Site Plan Subcommittee

Re: P.Z. 5 & 5(a)-16 Stonecrest

- I. Welcome To Attendees And Roll Call Of Commission Members
- II. Review Tonight's Agenda/Questions Or Comments
- III. P.Z. 5 & 5(A)-16 Stonecrest – Review And Discussion Of The Site Development Plan (SDP) And Related Items For A Senior Care Facility Consisting Of Up To Ninety-Five (95) Beds; Amended C-8 Planned Commercial District (Town Center “Neighborhood General District”); North Side Of Plaza Drive, South Of State Route 100. (Ward Eight)

C1

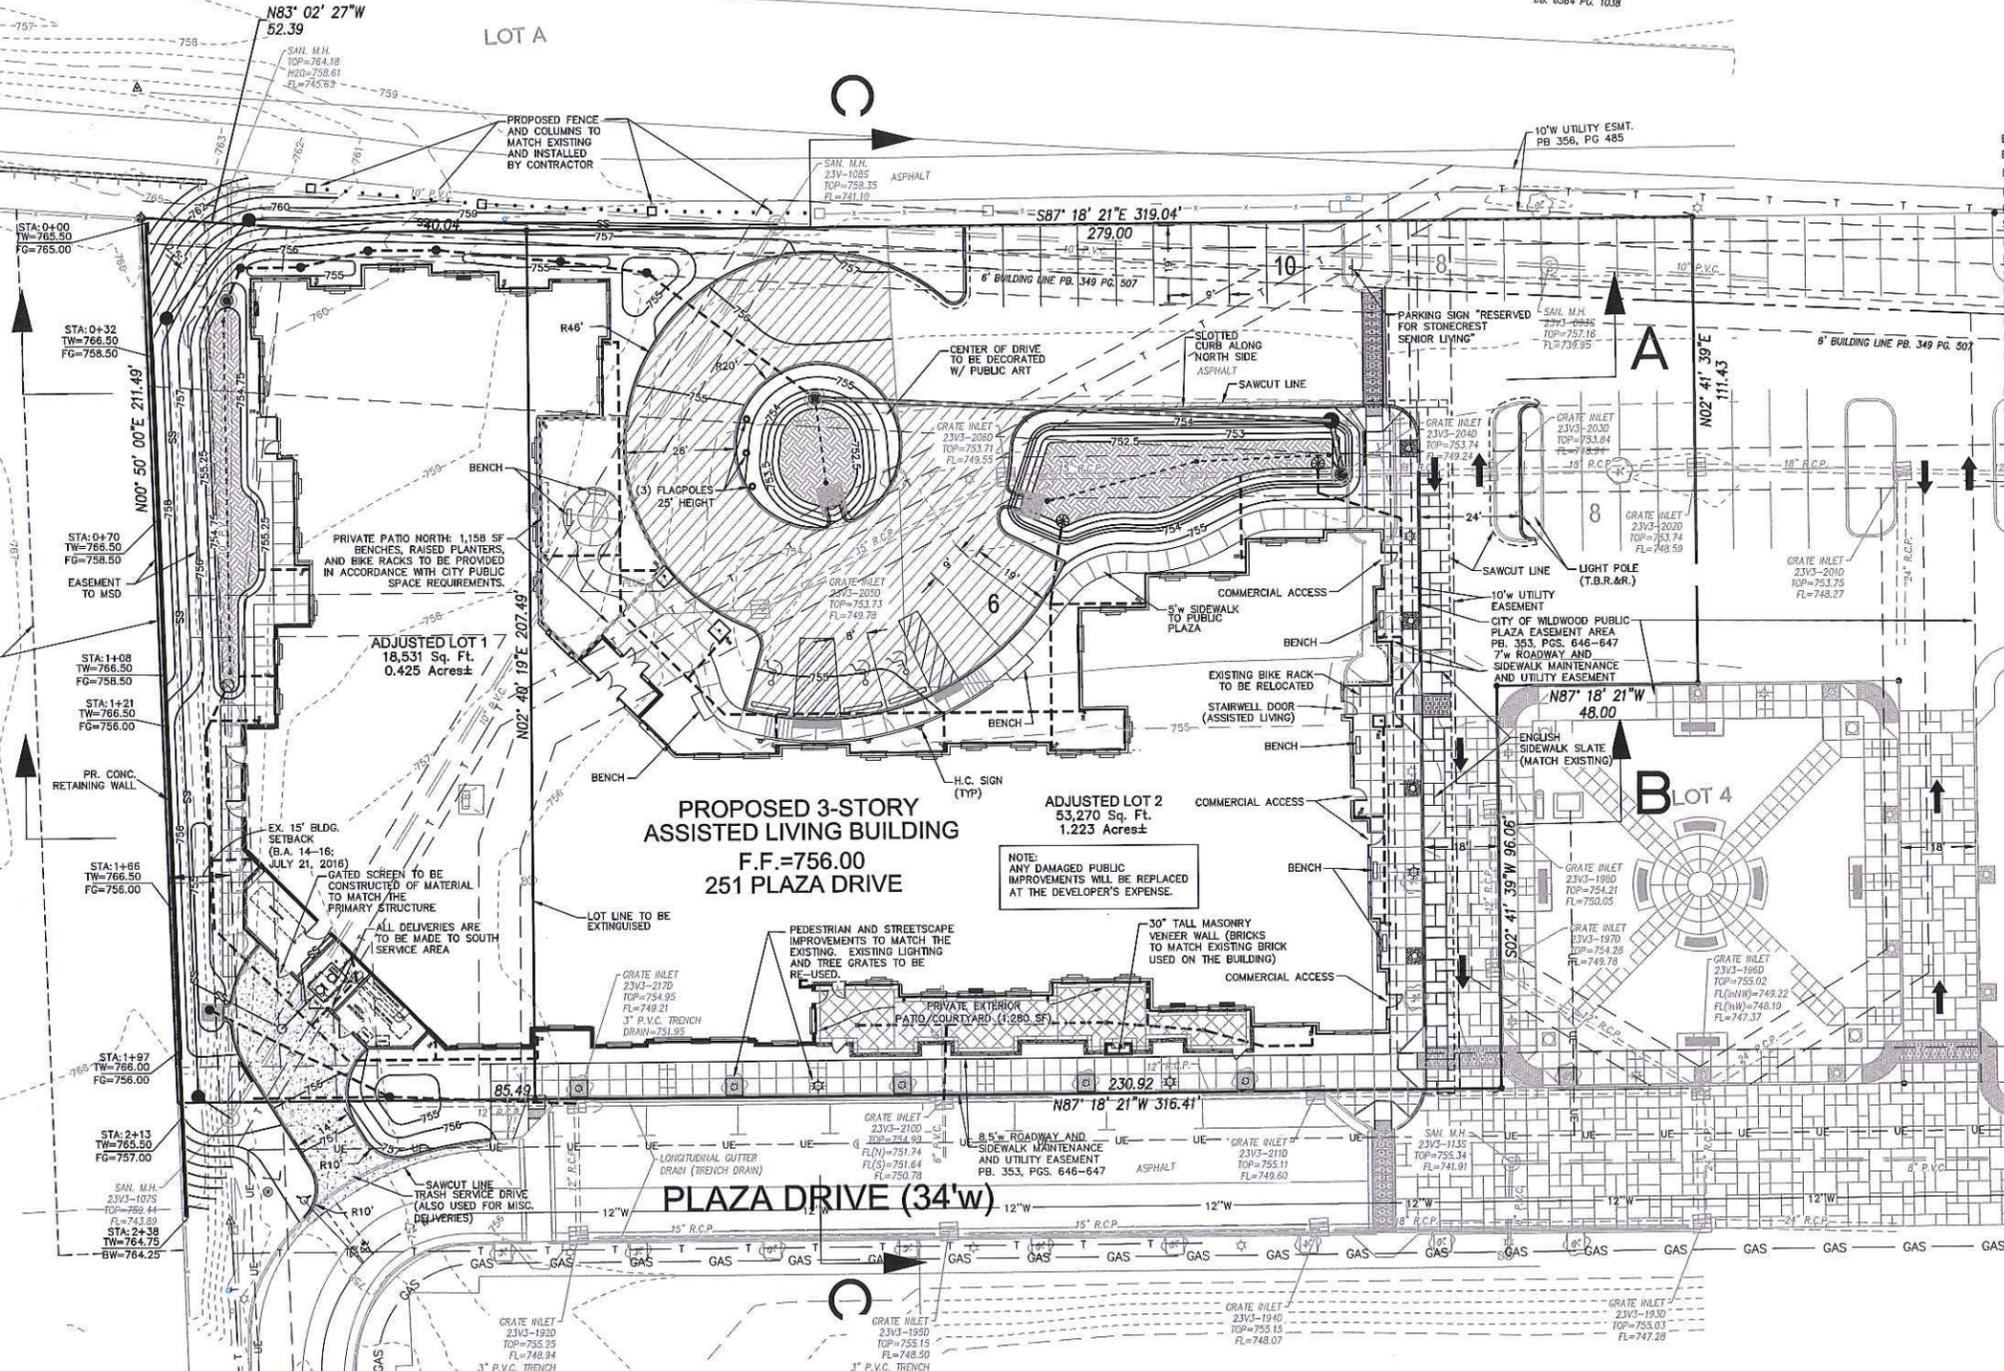
Comment 25. Please add "Police: St. Louis County Wildwood Precinct" and "Ward: Eight" to the Pertinent Data section on Sheet C1.

25. Please add "Police: St. Louis County Wildwood Precinct" and "Ward: Eight" to the Pertinent Data section on Sheet C1.

VERSA-LOK RETAINING WALL TYPICAL SECTION

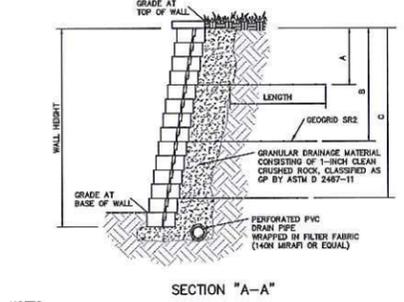
Comment 9. Please clarify if the retaining wall along the western property line is to be poured-in-place concrete type or the Versa-Lok System shown on Sheet C3.

9. Please clarify if the retaining wall along the western property line is to be poured-in-place concrete type or the Versa-Lok System shown on Sheet C3.
